Subject: Approval, Replacement System Variance Request, Sorbus Property, 406 Cony Road, Augusta

# REPLACEMENT SYSTEM VARIANCE REQUEST

# SUBSURFACE WASTEWATER DISPOSAL SYSTEM APPLICATION

**DISPOSAL AREA CROSS SECTION**

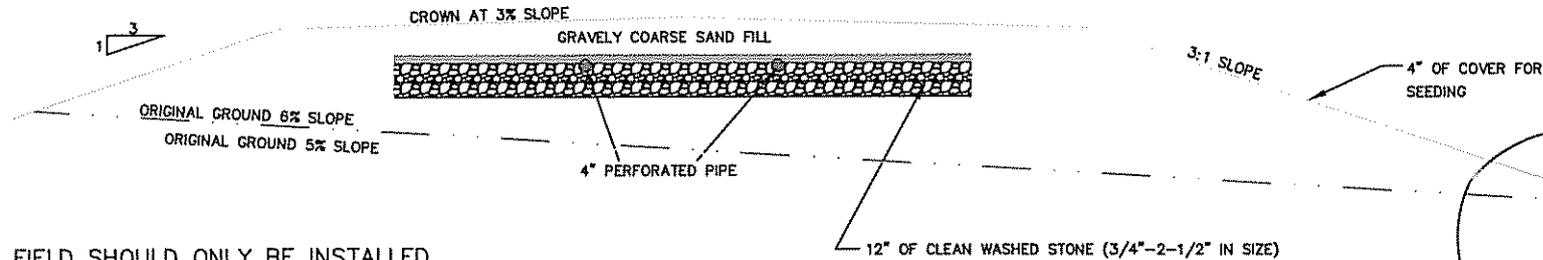
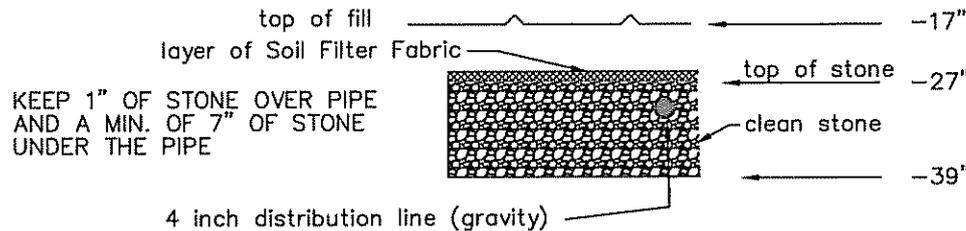
- 1. To install a disposal area in soils with a depth to the seasonal high groundwater table of seven inches.

## SUBSURFACE WASTEWATER DISPOSAL PLAN

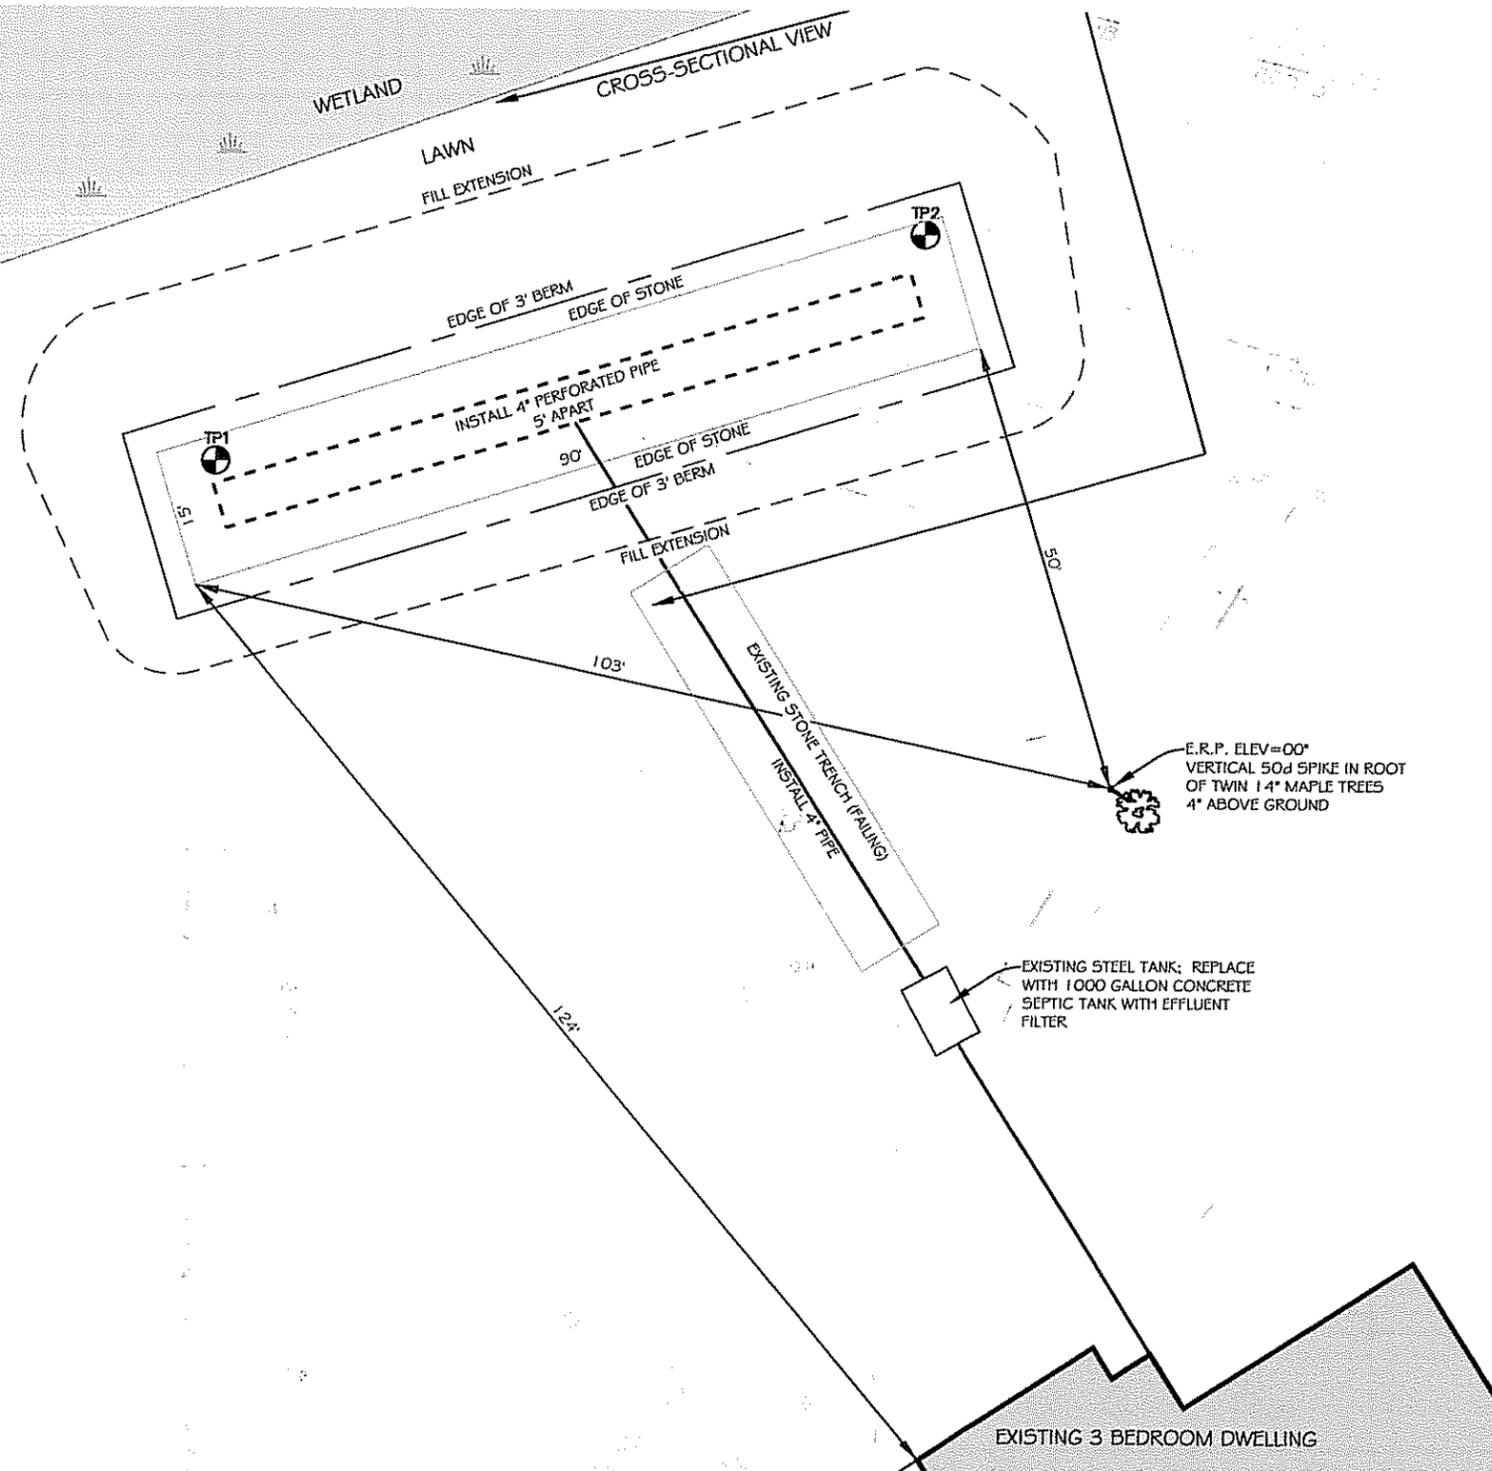
- 1. To install a disposal area with fill extensions set back eight feet from a wetland.

- 1. Prior to issuance of a permit, the Site Evaluator shall provide the Local Plumbing Inspector with a revised page 1 of the HHE-200 Form containing the latitude and longitude for the disposal area.
- 2. The disposal area and fill extensions shall be immediately stabilized against erosion; in particular the down slope fill extension shall be stabilized with coco-mat or a similarly effective material. Siltation fence shall be installed down grade of the disposal area, keyed into the ground and maintained until the fill extensions are vegetated.

**SUBSURFACE WASTEWATER DISPOSAL PLAN**

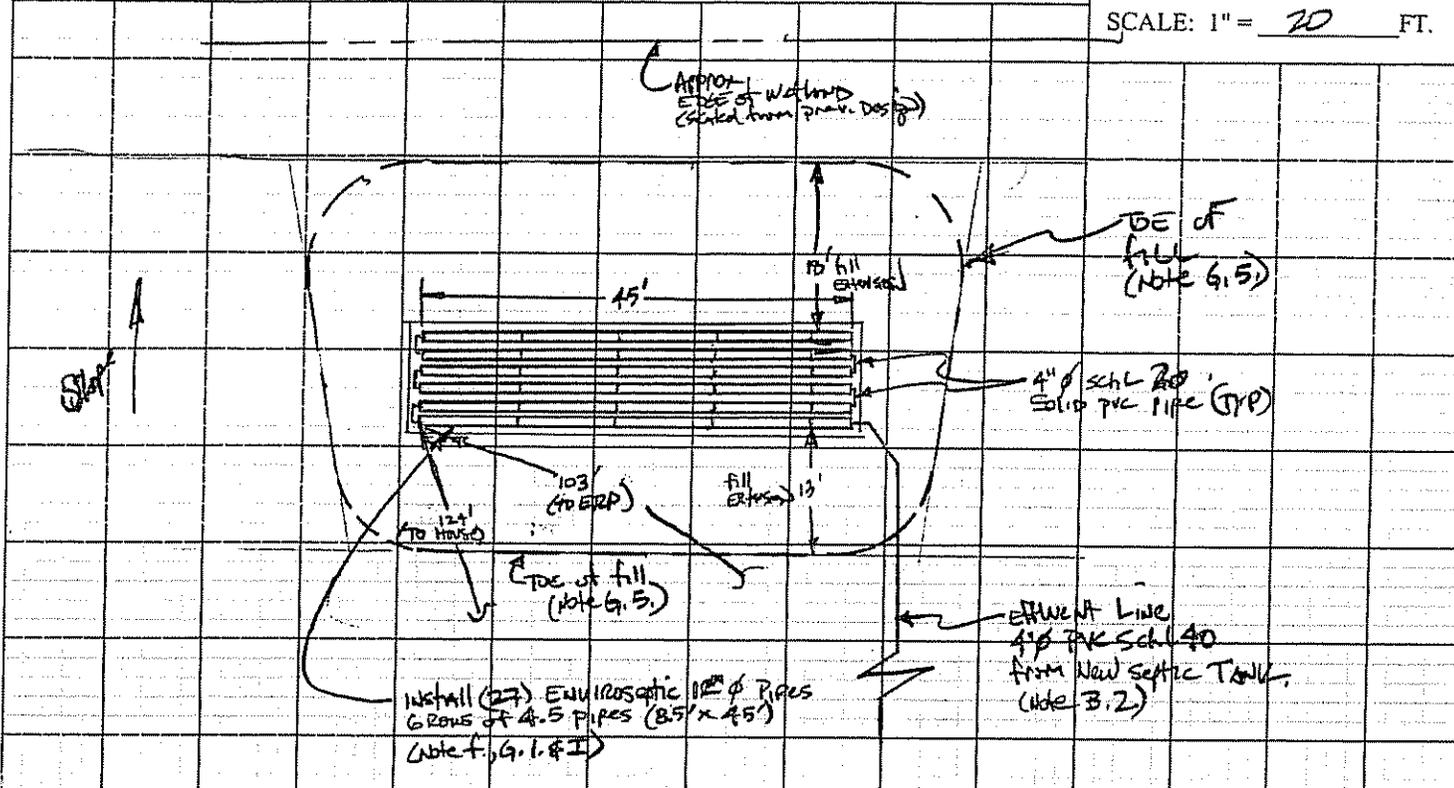
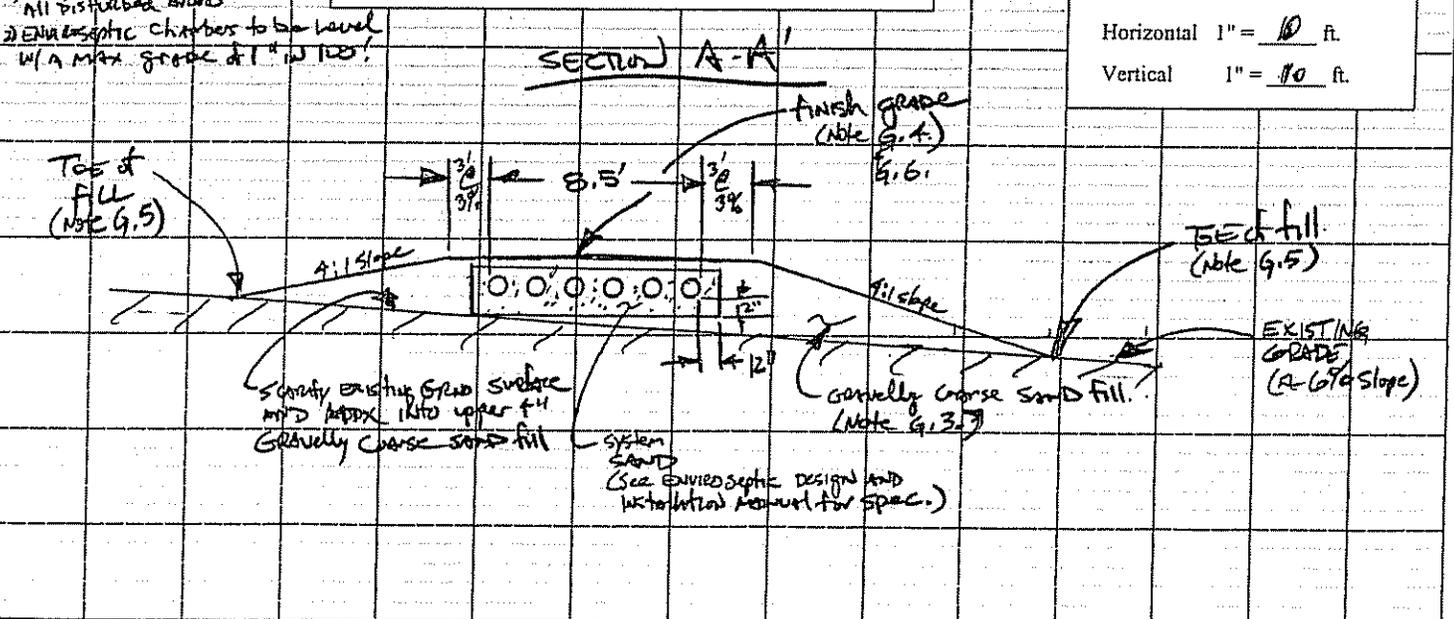
Request by S.J. Sobus to change leach field to ENVIRONMENTAL SEPTIC DESIGN. Originally Designed by K.P. Cottin (#331) DATE AUGUST 5, 2006.
